December 5, 2006

Re: Progress Update
GE Puerto Rico Investment, Inc. at Patillas, Puerto Rico
EPA ID# PRD090492109

Re: Review of Supplemental RFI Report
GE Puerto Rico Investment, Inc. at Patillas, Puerto Rico
EPA ID # PRD090492109

<<Figure 1_Alternative location_3_14_06_.pdf>>

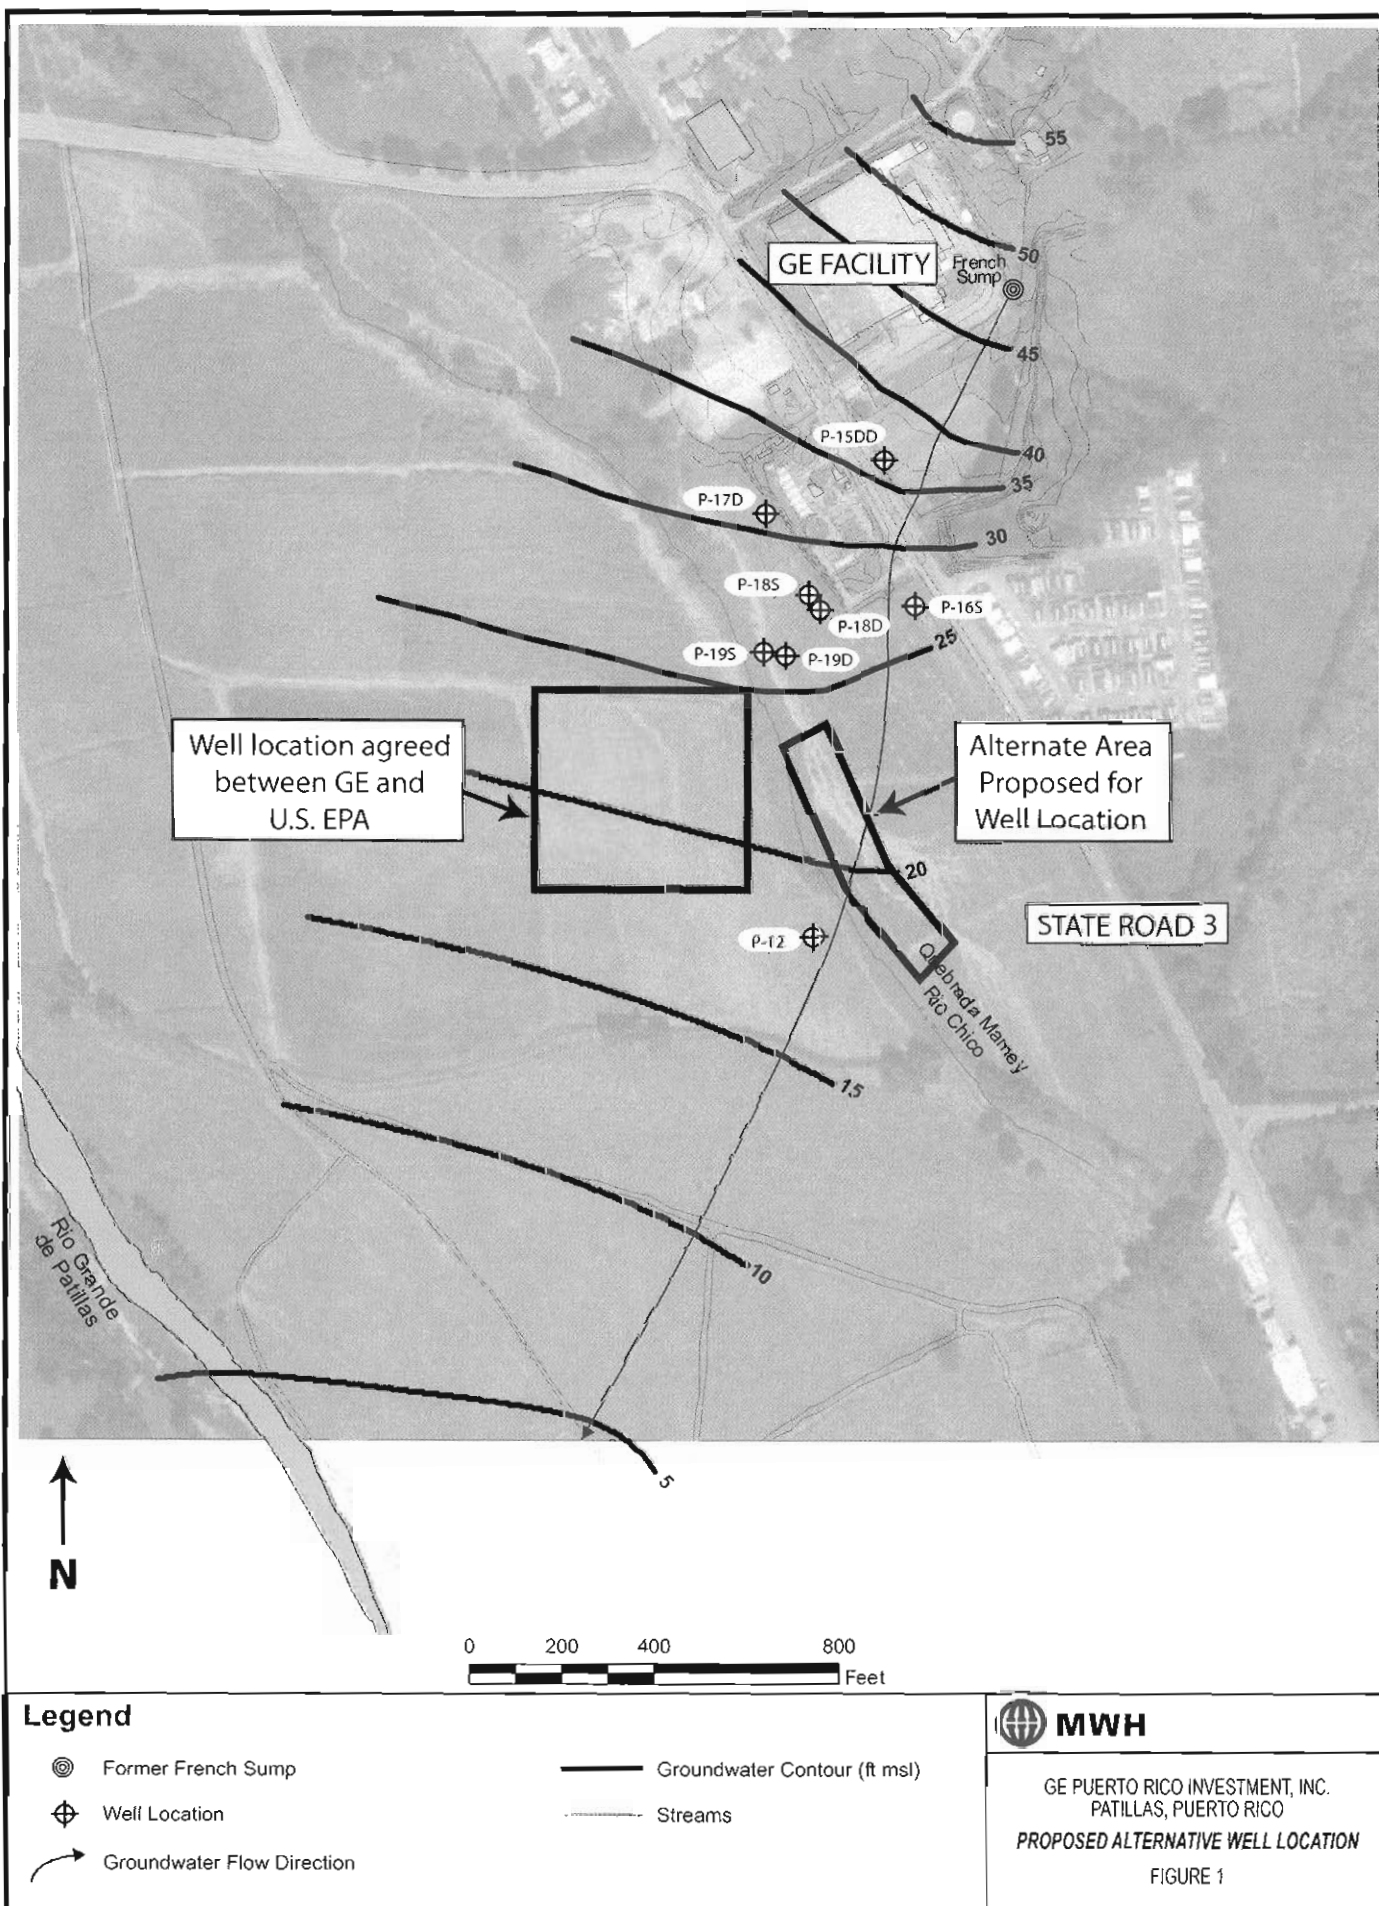
The alternate location is not the best one I like to see, but knowing the general direction of the flow, it is probably within the range. Please locate the well near the top of the alternate location box you proposed on the map. In the mean time, GE needs to continue to try to gain access to the the property, as down the road GE would need to access to those propoerties. Please keep EPA informed of your efforts in that regard and cc us on all correspondence, so when you are unsuccessful, EPA will involve.

We are encountering some issues trying to get our new well cluster located across the river in the box we discussed. I have met with my team and we feel that the alternate location identified on the attached map would be a better alternative approach that would keep us on current schedule of well installation and sampling in March so that another round can be collected in June. If we do not select this location, we will not be able to get the wells in this quarter and resampled again this summer so that you can have the results before the fall. Can you confirm that you are OK with this alternative approach by e-mail or call me so that we can discuss? If you need to reach me, you may need to call my cell phone 502-514-1997 as I am in lots of meetings and traveling part of this week.

Pursuant to our discussion, GE will install the new well cluster in the box labeled "alternative area proposed for well location" as close to the "X" where the hypothetical flow line crosses the 20 ft msl contour. This new well will provide additional data about groundwater quality and flow direction.

Proposed new well
location.pdf...

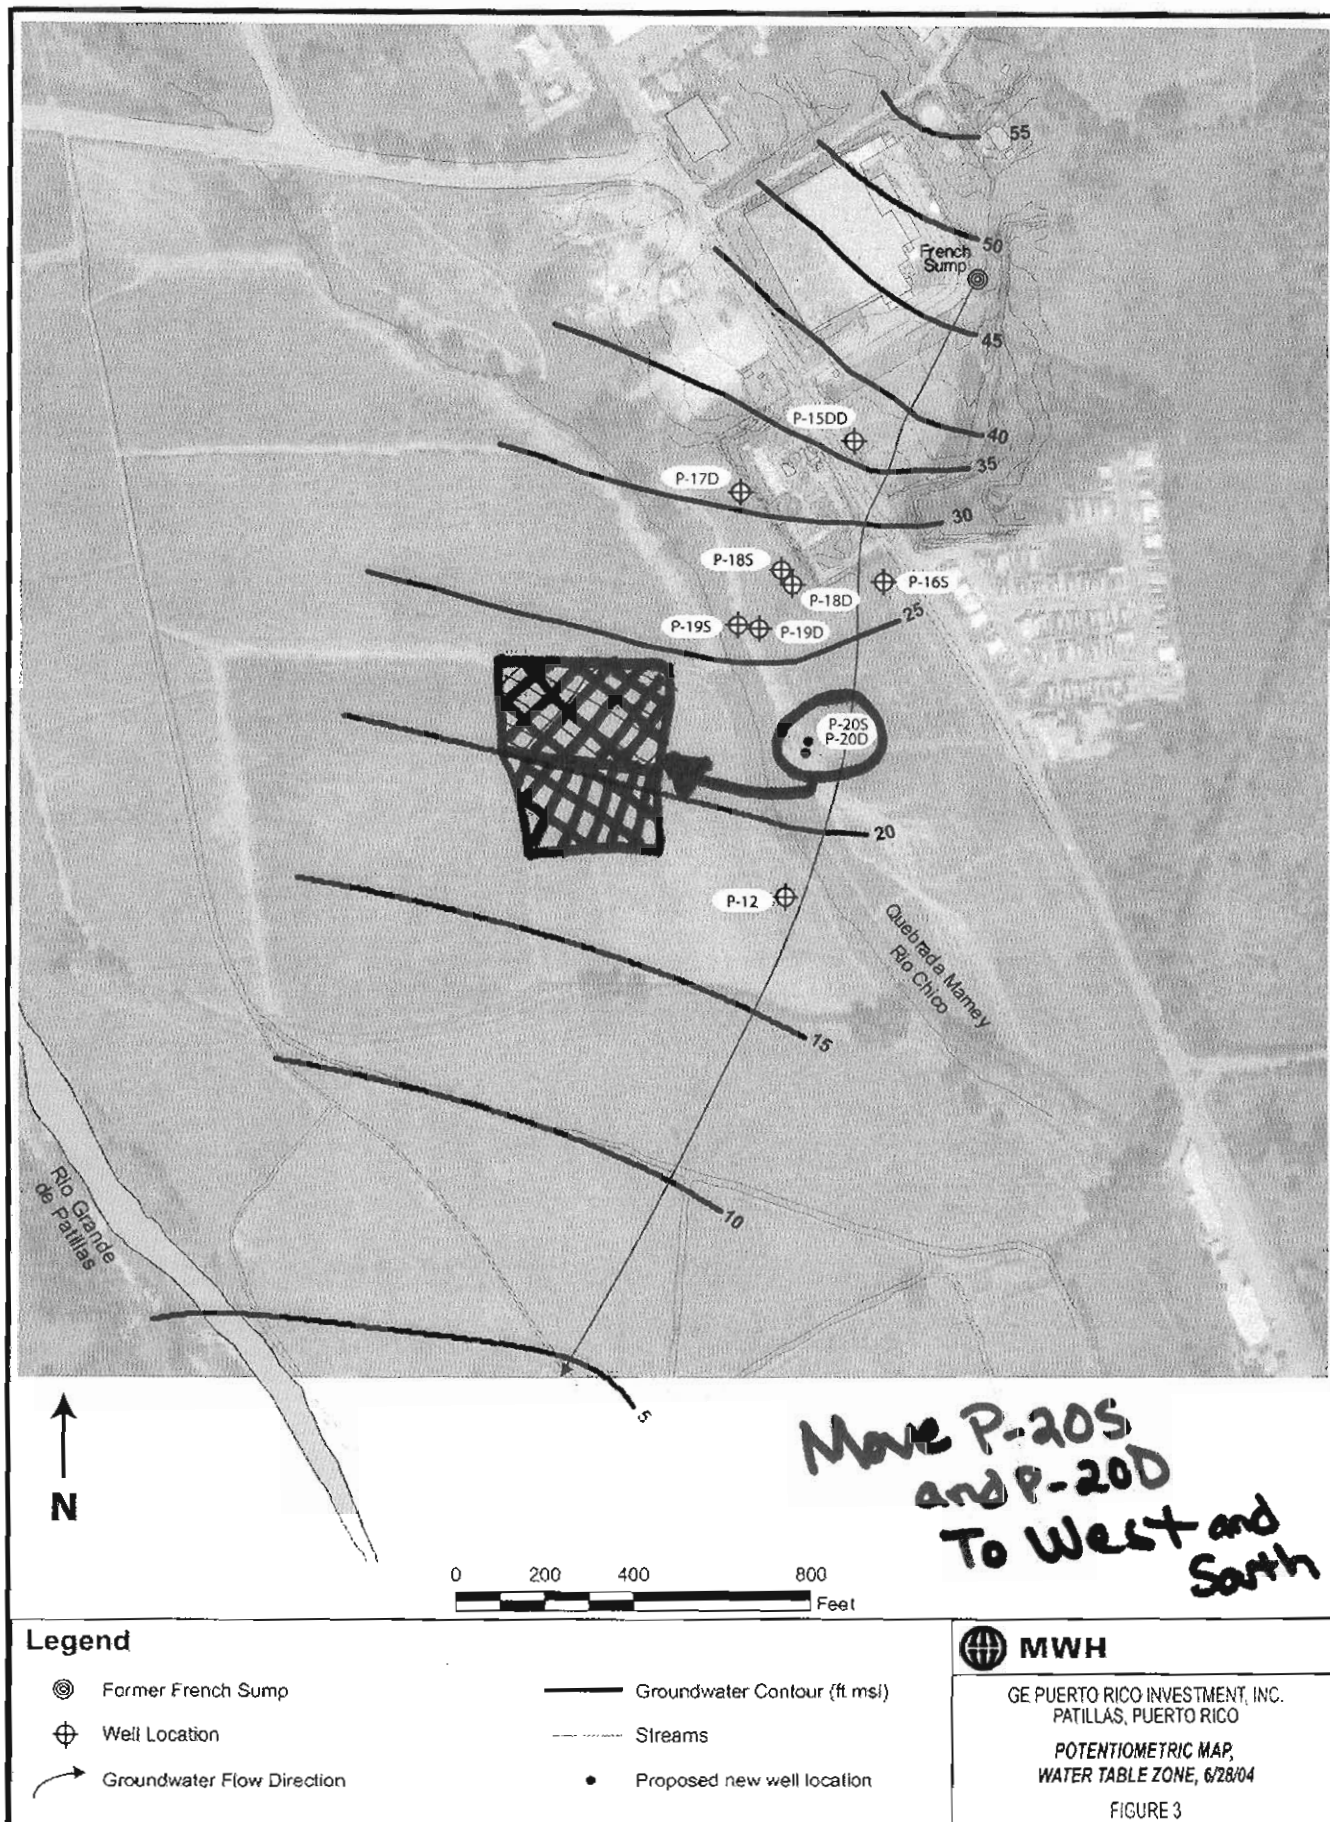
> Sin-Kie,
>
> If you reply affirmatively to the proposed new well cluster location
indicated on attached map, I will plan to do the following:
>
> 1) Install new downgradient well cluster (P-20S and P-20D) in March
2006
> 2) Sample the new downgradient well cluster (P-20S and P-20D) in March
2006 (this will be round #1)
> 3) Sample 7 other wells (6 off-site wells: P-16S, P-17D, P-18S, P-18D,
P-19S, and P-19D; and 1 deep on-site well: P-15DD) in March 2006 (this
will be round #3)
> 4) Sample the new downgradient well cluster (P-20S and P-20D) in June
2006 (this will be round #2)
> 5) Sample 7 other wells again in June 2006 (this will be round #4)
> 6) Submit data and work with you to support EI-750 determination in
September 2006 timeframe

As outlined in the September 2005 letter, GE would perform additional groundwater sampling activities necessary to delineate the extent of plume outside the GE facility boundary. In December, GE performed the round #2 sampling at the 6 off-site wells and 1 well inside the facility boundary. Consistent with the agreement reached in the September 2005 letter, GE now proposes to install a new down-gradient well cluster in early March, 2006. Based upon the discussions we recently held, EPA hereby concurs with the proposed general location for the proposed new well cluster, which is intended basically as the replacement for the old down-gradient well P-12 which could not found and presumably totally damaged. In addition to the installation and sampling of this new down-gradient well cluster, GE would continue to perform round #3 sampling (scheduled for March) and round #4 sampling (scheduled for June) at other off-site wells. By September 2006, I hope we would have enough data in hand to make the EI-750 determination.
